Representation - Draft Amendment 58, DA0472/2019

I act on behalf of Mr Clifford Partridge and Mrs Moira Partridge, who own and occupy property at 13 Magpie Crescent, St Leonards, and provide the following representation to the currently advertised Draft Amendment 58 and DA0472/2019 for a Section 43a Application for combined rezone and subsequent development of a 30 lot subdivision and roads.

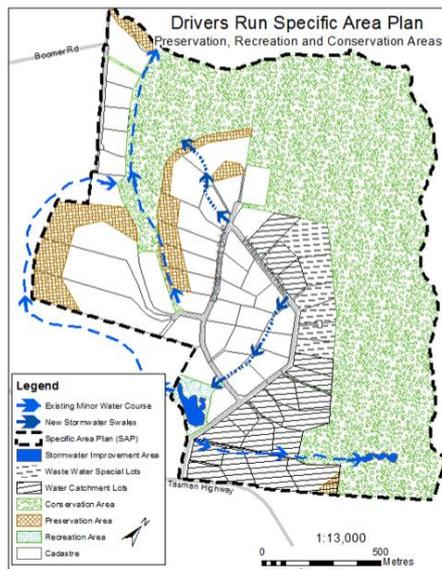
The advice of TasWater and the costs involved to upgrade and extend the existing reticulated water supply does not raise any unusual engineering issues. The topography is not unusual and does not prevent supply. The concern from TasWater in relation to the existing pump station at the Distillery Creek water treatment plant, is not unusual, in that during power outages, it is typical that water supply is affected during a bushfire. This is not a stand-alone event. Contingencies in the event of power failure is a general concern that needs further consideration of TasWater and is not isolated to this proposal alone. If that were the case, then all land is not capable of being connected due to the risk of a power outage in the event of a bushfire event. Therefore, reticulated water supply should be connected to the subdivision and the Amended SPAN (highlighted in RED) as included must

be conditioned on any approval. It is unclear by the draft permit, whether this is to be required or not.
